**Review of the
Canton Mountain Wind Project
Visual Impact Assessment**

Prepared for
Maine Department of Environmental Protection
Augusta, Maine

March 20, 2012

Figure 1. A draft of Photosimulation 3 from Forest Pond showing how the WindPRO drawing is registered to the photograph by aligning the landform ridge line. *Source:* TJD&A 2011.

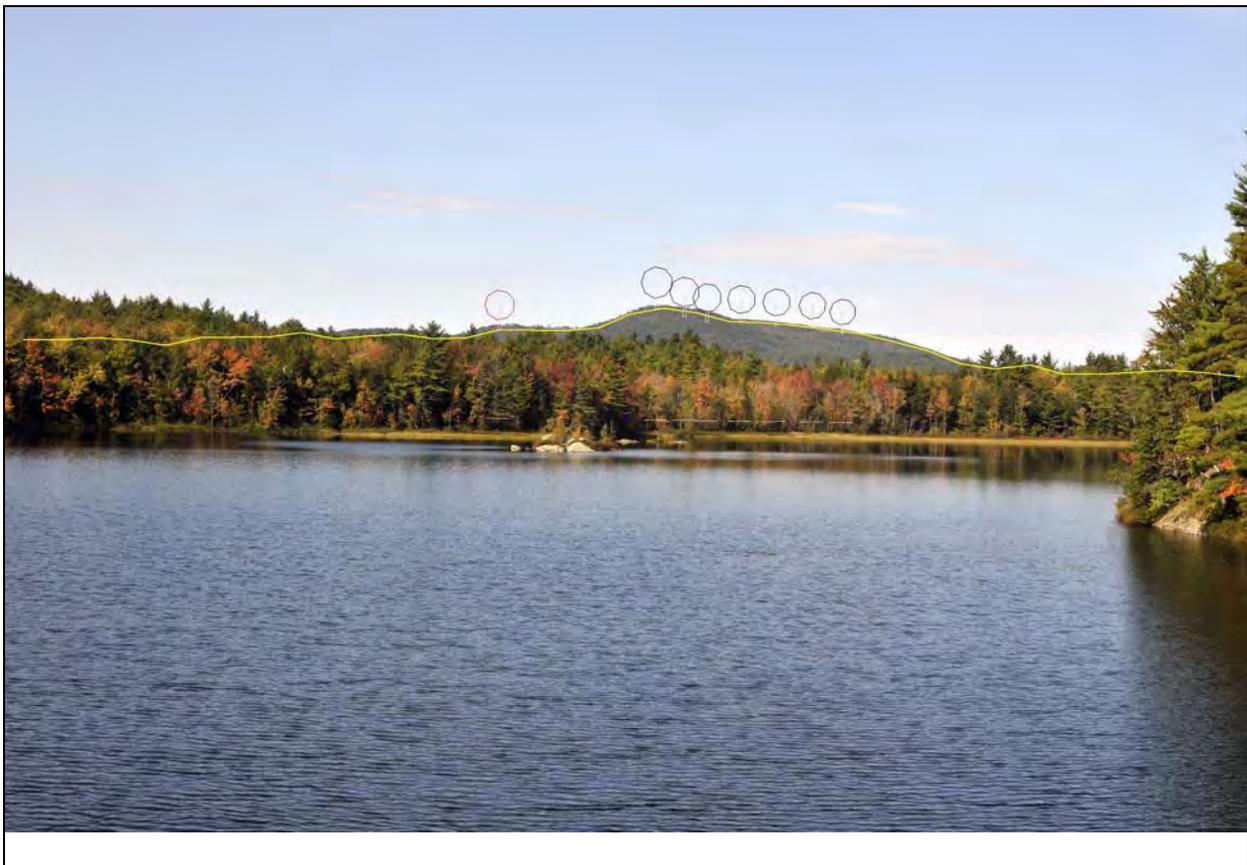
While there is some interpretation that must be made to create photosimulations, those presented in the VIA appear generally accurate and well-constructed, as is apparent when compared to the ArcScene Visualizations in Appendix 3.

Forest Pond—Viewpoint 3. The scope and scale of Visualization 3 is very similar to the photosimulation in the VIA’s Figure 3A. This supports the accuracy of the photosimulation.

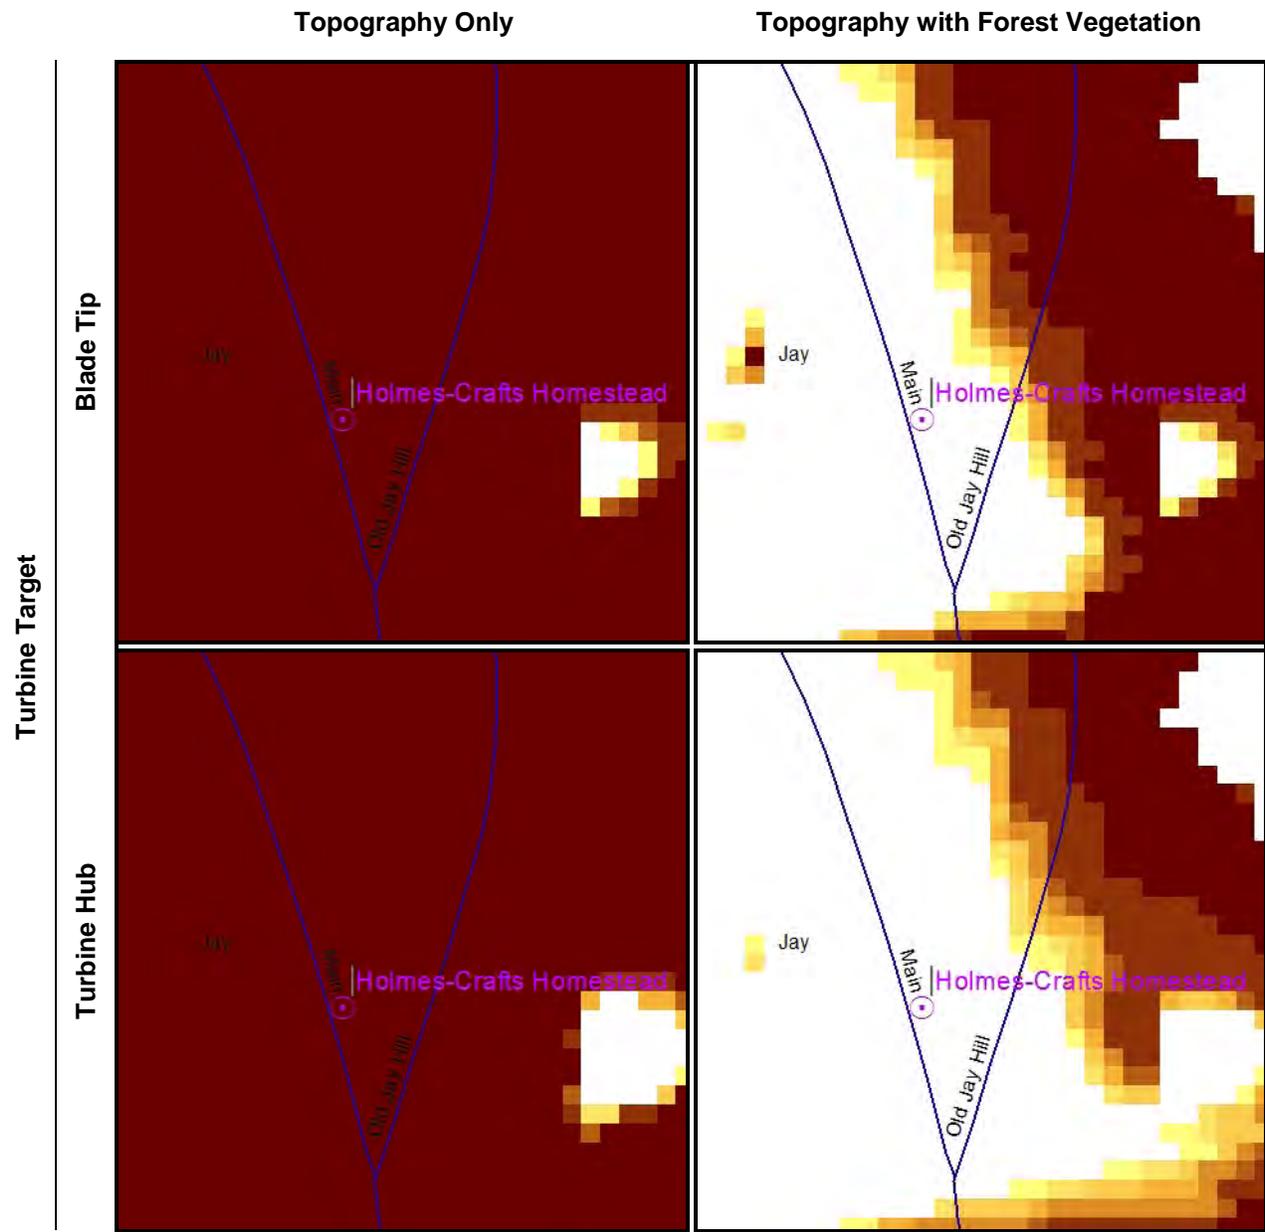
The area around each of the SRSNSs is reproduced at a larger scale (i.e., close up) and presented in Figure 2 through Figure 7. Only the Nelson Family Farm apparently has no potential visibility of the Canton Mountain Wind Project (i.e., the visibility analysis found that topography alone screened all of the blade tips). However the analysis also indicates that forest cover is very likely to screen the view of the turbines at the Holmes-Crafts Homestead and very possibly Nelson Pond.

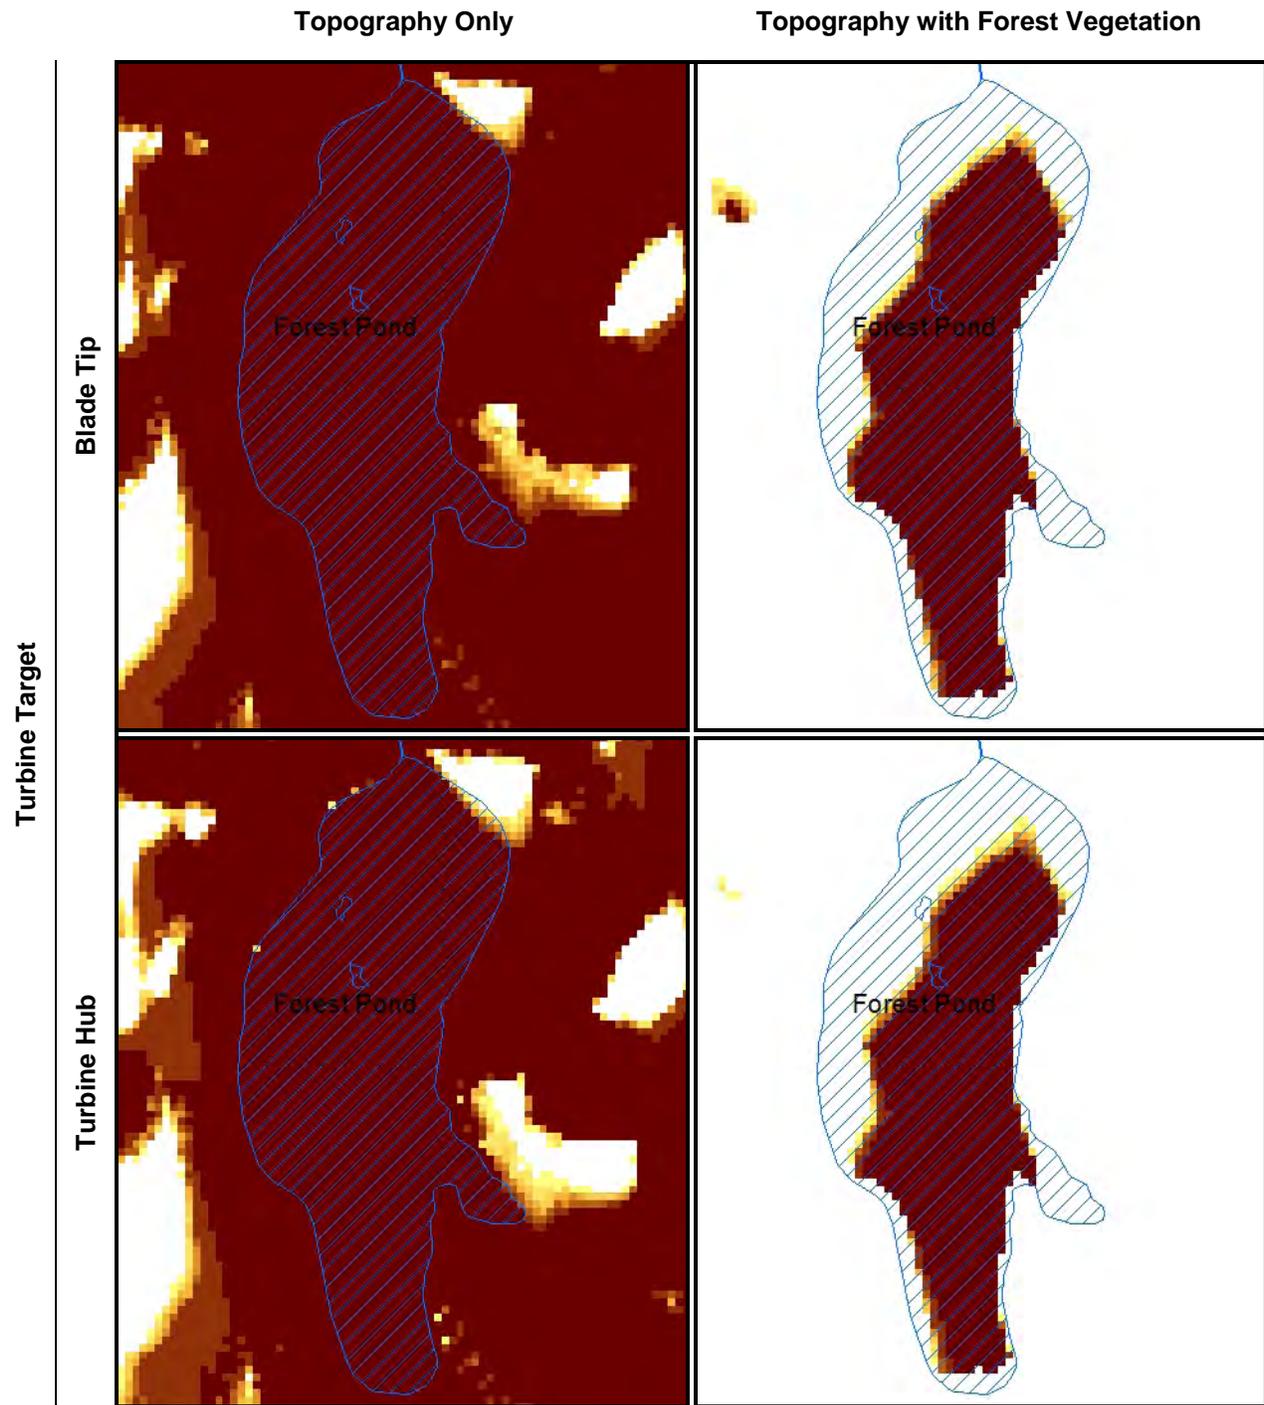
1. There is little consideration of scenic impacts from FAA night-time warning lights on the wind turbines. These lights will be very visible from Forest Pond, and are likely to produce the red streaking “pillar” reflections produced by other projects. While there may be few users of Forest Pond to see this impact, it should still be described. The impacts to the Jay-Niles Memorial Library and North Jay Grange Store are not considered at all.
2. It appears that the public does not have a legal right of access to The North Jay Grange Store, which has potential visibility and is listed on the National Register of Historic Places. As a result it cannot be considered SRSNSs (35-A MRSA, § 3452, sub-§3). Formal documentation should be presented verifying that this is so.

Visualization 1: Jay-Niles Memorial Library (Photosimulation 1A)

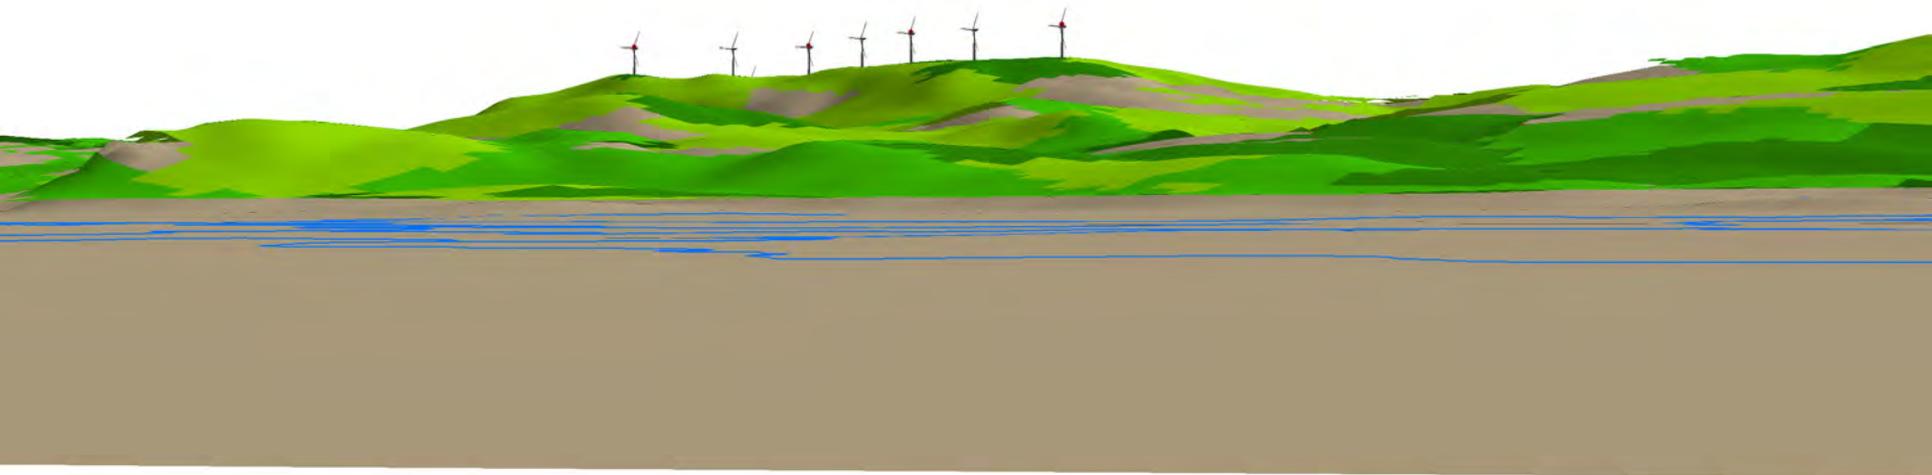
Jay-Niles Memorial Library—Viewpoint 1. The library is in a settled area with buildings and landscaping trees that are not represented in the GIS data. However, the scope and scale of Visualization 1 is very similar to the photosimulation in the VIA’s Figure 1A. It appears that the turbines will largely be screened by these urban elements. This supports the accuracy of the photosimulation.
